ADDENDUM TO THE UC DAVIS RENEWABLE ENERGY ANAEROBIC DIGESTER PROJECT TIERED INITIAL STUDY AND NEGATIVE DECLARATION

(State Clearinghouse No. 2012072005)

March 2019

**Figure 1 - Modification #2: Effluent and Solids Treatment**

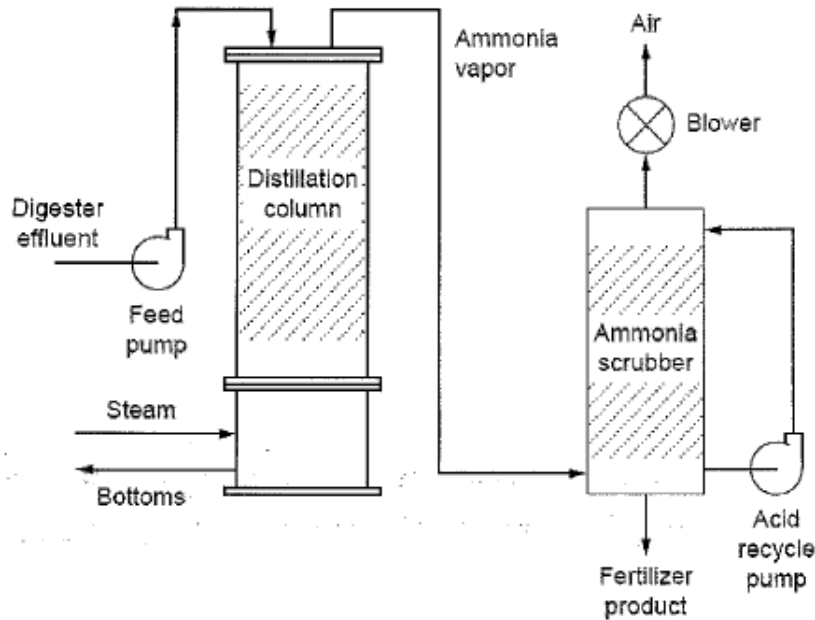
In the proposed deammonification system, digestate is contacted with an air-steam mixture in a distillation column. The high temperatures help to strip the ammonia from the digestate, such that only 10% of the initial ammonia remains in the treated digestate. This ammonia level is sufficiently low that the digestate can be treated in the WWTP. The proposed deammonification system would be installed within the existing READ Biodigester footprint.

The proposed digestate ammonia removal process (Figure 1) consists of two landfill/biogas operated steam boilers, distillation column, two condensers, ammonia scrubber, circulation pump, acid dosing pump, acid storage, blower, and other ancillary equipment. The distillation column would produce a vapor that contains mostly carbon dioxide and water, with up to 5% ammonia (by volume). This vapor stream would not be suitable for release to the atmosphere without treatment, so it would be routed to a scrubbing column where ammonia would be removed by a dilute sulfuric acid solution. The proposed acid scrubber, Envitech's Packed Bed Ammonia Scrubber, guarantees an ammonia removal efficiency of greater than 97.5%. The sulfuric acid solution would absorb the ammonia to form aqueous ammonium sulfate. The liquid ammonium sulfate would be a stable solution that could be used as fertilizer by local farmers. The treated vapor would be vented to the atmosphere and would contain traces of ammonia.

For heating the digestate, UC Davis has a list of three proposed small boilers certified by the South Coast Air Quality Management District (SCAQMD) as compliant with the requirements of Rule 1146.2. The specifications for all three boilers are attached to this application. The proposed boilers will be approximately 1.6 MMBTU/hr. each (3.2 MMBTU/hr. total) maximum heat input rating.
